# Access Compliance Report

## Public Rights-of-Way

### (Curb Ramps)

Intersection ID: 52630	Main Street: WEYMOUTH_LN	Cross Street: ALEXANDER_DOWD_DR	Location: SE
ADA ID: 1498EB0CBD50	Ramp Type: Perp	Initial Pass/Fail: Fail	Overall Compliance: No
Severity Score: 12.5			
Codes/Mitigation Info/Possible Solution		Field Measurements/Component Compliance

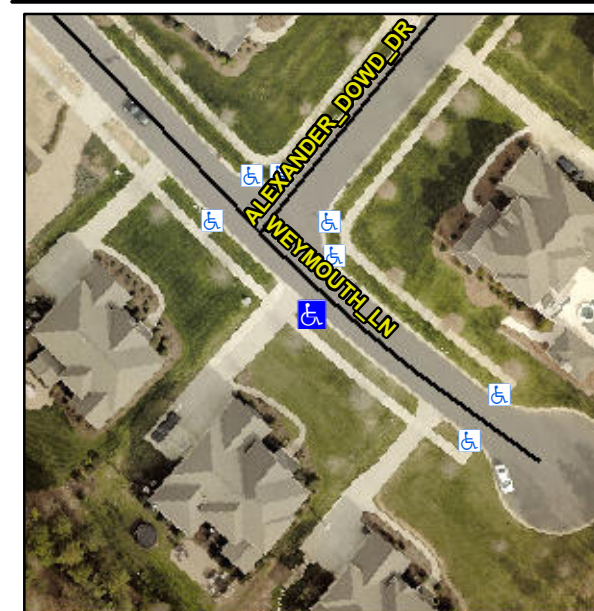
**Not Found, R304.5.3**

Compliance	Description	Data	Compliance	Description	Data
N/A	Ramp Length (in)	96.0	Yes	Ramp Slope (%)	8.3
Yes	Ramp Width (in)	61.0	No	Ramp XSlope (%)	5.8
N/A	Flare Type LT	N/A	N/A	Flare Type RT	N/A
N/A	Flare Slope LT (%)	N/A	N/A	Flare Slope RT (%)	N/A
N/A	Flare Traversable LT?	N/A	N/A	Flare Traversable RT?	N/A
N/A	Landing Length (in)	N/A	N/A	DWS Provided?	N/A
N/A	Landing Width (in)	N/A	N/A	DWS Contrast?	N/A
N/A	Landing Slope (%)	N/A	N/A	DWS Length (in)	N/A
N/A	Landing X Slope (%)	N/A	N/A	DWS Full Width?	N/A
N/A	Landing Curb? (Y/N)	N/A	N/A	DWS Offset (in)	N/A
N/A	Shared Landing?	N/A			
N/A	Gutter Ponding?	N/A	N/A	Gutter Slope (%)	N/A
N/A	Gutter Lip Ht (in)	N/A	N/A	Gutter X Slope (%)	N/A
N/A	Painted X Walk1?	No	N/A	Painted X Walk2?	N/A
	X Walk 1 Direction	To NE		X Walk 2 Direction	N/A
N/A	X Walk 1 Width (in)	N/A	N/A	X Walk 2 Width (in)	N/A
	X Walk 1 Slope (%)	5.5		X Walk 2 Slope (%)	N/A
	X Walk 1 X Slope (%)	4.2		X Walk 2 X Slope (%)	N/A

**Remove & Replace Entire Ramp.**
